- 2. The applicant, Paso Highway Hotel Partners, LP, has requested the Planning Commission consider a modification of the approved site plan and hotel building elevations, which would reduce the total building square footage from 98,000 square feet to 72,890 square feet. This is proposed to accommodate a change in hotel brand from a Marriott Residence Inn "extended stay" hotel to a Fairfield Inn and Suites, by Marriott. See Attachments 2 and 3, comparison of plans. No other changes are proposed with this application.

RESOLUTION OF THE PLANNING COMMISSION OF THE CITY OF EL PASO DE ROBLES AMENDING THE SITE PLAN AND ELEVATIONS FOR PLANNED DEVELOPMENT 15-003 (PASO HIGHWAY HOTEL PARTNERS, LP 2940 UNION ROAD, APN 025-362-004)

RE: Fairfield Inn Hotel Union Road Paso Robles, California

Attachment 2

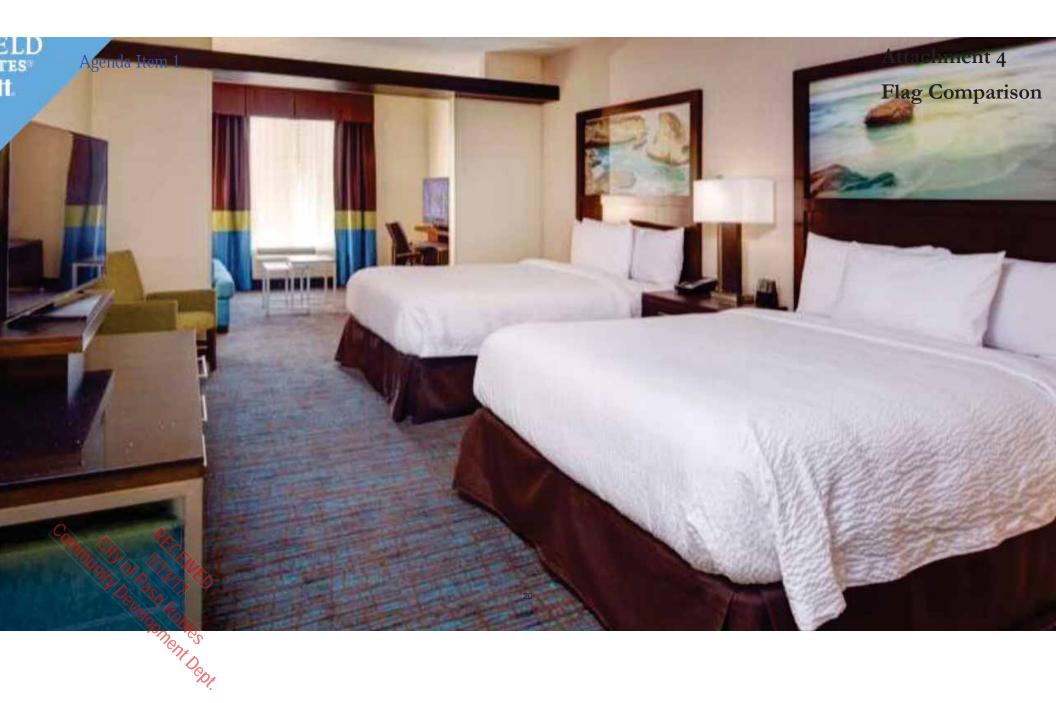
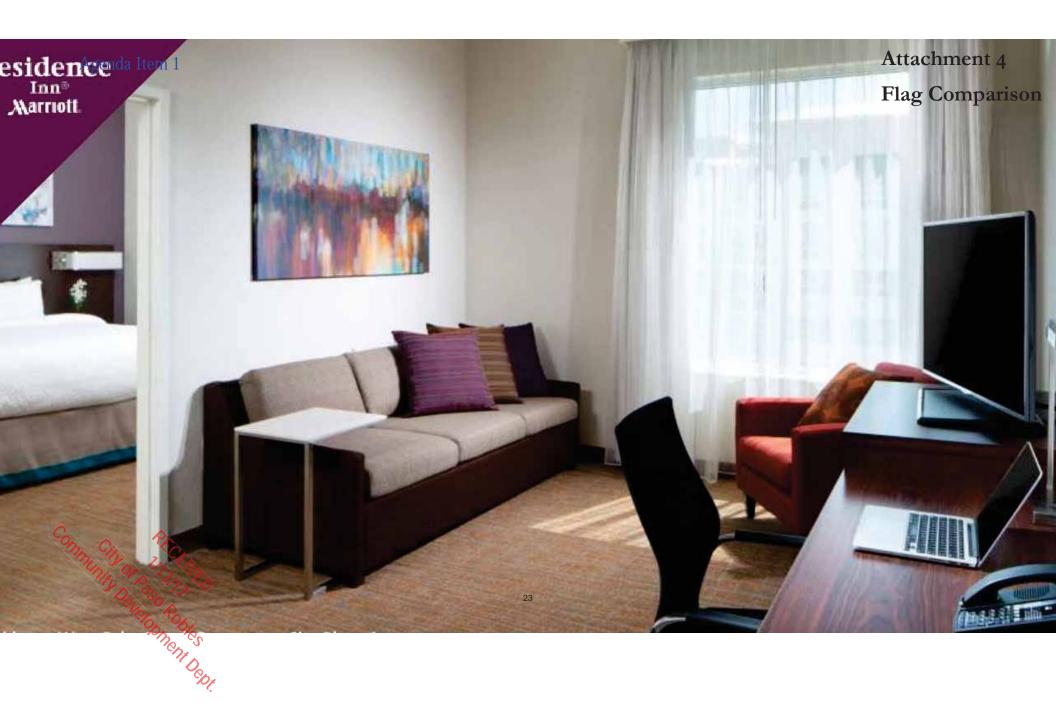
- 6. The site plan includes the same number of parking spaces, however the rear parking spaces are proposed to be modified to provide a more efficient use of the site. The revised parking lot design complies with planning and emergency services requirements. See Attachment 2, Approved and Proposed Site Plan.

Attachment 3 Elevation Comparison

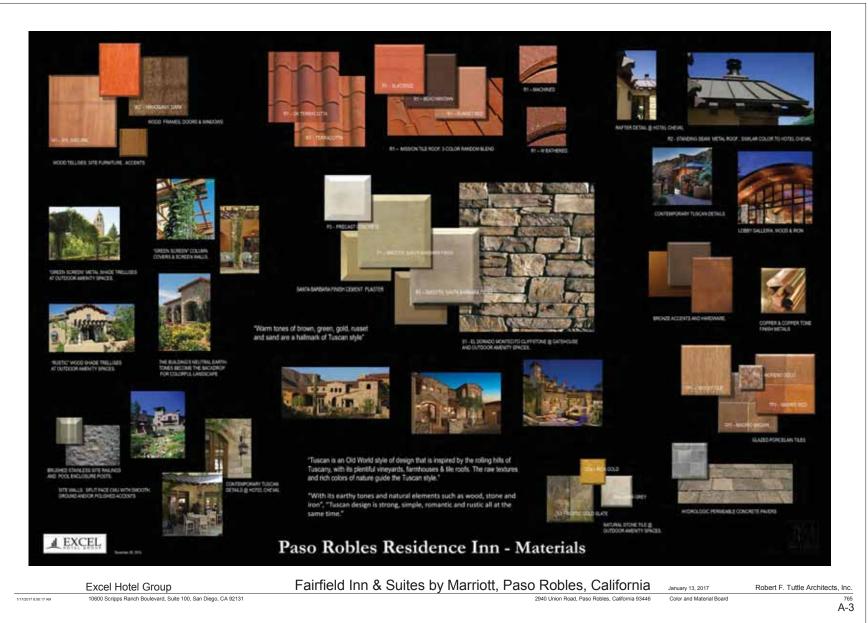
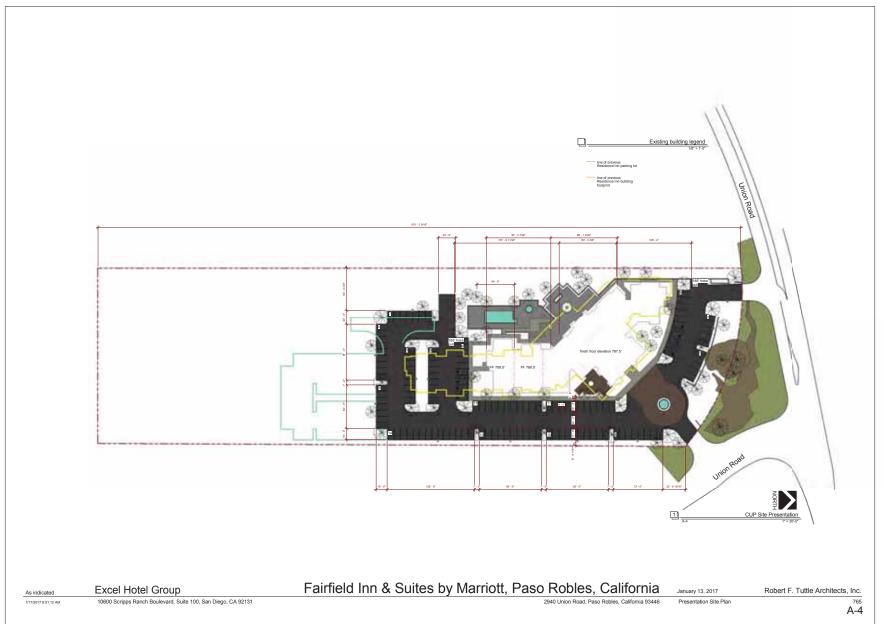
- 1. Building Square Footage
 - a. RI approved footage: 98,000 SF
 - b. FI proposed footage: 72,890 SF
- 2. Parking Stalls
 - a. RI Approved: 132
 - b. FI Proposed: 132
- 3. Parking Lot SF
 - a. RI Approved: 66,700 SF
 - b. FI Proposed: 49,046 SF
- 4. Landscape area
 - a. RI approved footage: 135,732 SF
 - b. FI approved footage: 153,001 SF
- 5. Exterior Materials and colors
 - a. All proposed exterior materials and colors are to remain the same as approved on the RI, with the exemption of the wood doors on the first floor. These have been changed to anodized aluminum to comply with brand standards. The materials and colors are shown on sheet A-3.
- 6. Roof pitch
 - a. RI approved pitch: 4:12
 - b. FI proposed pitch: 4:12

- 7. Extent of Exterior Stone
 - Two tower elements adjoining the main entry were approved with stone in the RI.
 Due to reduced scale and massing the stone was eliminated to be more proportional and balanced.

- 8. Main Lobby
 - a. FI public spaces are significantly smaller than RI so the lobby, dining room, and other public spaces have been reduced to reflect the FI project. Even though the overall size of the lobby is smaller, it is proportional to the overall building design.

- b. The front entry barrel roof has reduced prominence. The barrel roof proposed is slightly narrower than the approved barrel roof. For this reason, the height was reduced by a corresponding amount.

- 9. Main Entry
 - a. The front steps approved on RI are no longer necessary for a change in grade and are deemed unsafe and not desirable with both the franchise and the owner. The steps have been eliminated.

- b. FI primary entrance doors, secondary public, and mullions are shown with correct materials and colors (dark bronze aluminum). The RI primary entrance does not accurately depict the approved doors and mullions.

- 10. Fourth Floor Balconies
 - a. Remains unchanged
- 11. Roof Exposed Rafters
 - a. The Roof exposed rafters are exposed wood and they remain the same.
- 12. Wood Trellis 1st floor

- a. Wood Trellis between the pop outs has been modified to fit the reduced geometry.
 An additional wood trellis has been added in the front near the Lobby.

- b. At the FI the columns supporting the trellis between the tower elements have been eliminated due to the reduced span.
- 13. A/C units
 - a. Residence Inn uses a vertical unit with a vertical grill. The approved design did not show these vertical grills.

- b. Fairfield uses a PTAC unit with a grill below the window. It is an integral grill, all part of the window.
- 14. Recessed arch window casings. The approved design shows recessed arch window casings, the proposed design shows arch window casings.

- 15. Corridor Windows
 - a. Windows were added in the FI design at the corridor in two locations. The windows bring light into a long corridor to enhance the guest experience. The windows are designed to match the windows on each end of the building at the corridor near the stair towers.
 - b. Window to the right of the entrance on RI had the top arched. The window on the FI is now a rectangular window. This is due to back of house program changes from the RI to the FI.
- 16. Roof Material
 - a. Tile roof is to match the blend on the material board used on both the RI and FI.
 - b. RI arched roof support color is wrong. Should match the wood shown in the FI (the dark brown).
